OAK CREEK SEWER AND WATER UTILITY
MILWAUKEE COUNTY, WISCONSIN

ADDENDUM NO. 3
PUETZ ROAD BOOSTER STATION

PART A- BOOSTER STATION CONSTRUCTION
PART B- TRANSMISSION MAIN CONSTRUCTION

PROJECT NOS. 08101 AND 08102

FOUNDATION AND WALL CONNECTION DETAIL

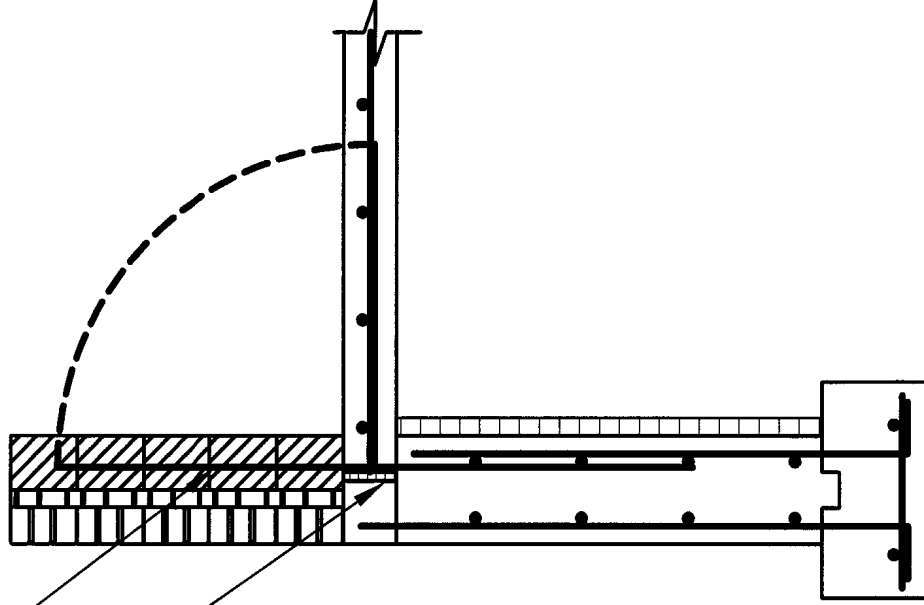
4. Plan Sheet 22, Drawing 100-AS-06, **to clarify**, Contractor shall provide roof exhaust fan enclosures (4). The enclosure shall be pressure-treated 2x4 framed and aluminum sided enclosure and the top cap to be aluminum clad. All fasteners shall be galvanized, aluminum, or stainless steel. The color shall match the soffit aluminum siding.
5. Plan Sheet 43, Drawing 200-AS-05, Detail B, **add** the following: Provide (2) 5/8" bolts with hooked ends at each beam connector (4" minimum). Provide additional bolts centered between beams.
6. Plan Sheet 44, Drawing 200-AS-06, **add** the enclosed Detail F – Foundation and Wall Connection Detail.

#4 x 6'-0" @ 12" O/C. FIELD
BEND INTO SLAB & LAP 3'-0"
W/ SLAB REINFORCEMENT.

2" RIGID
INSULATION
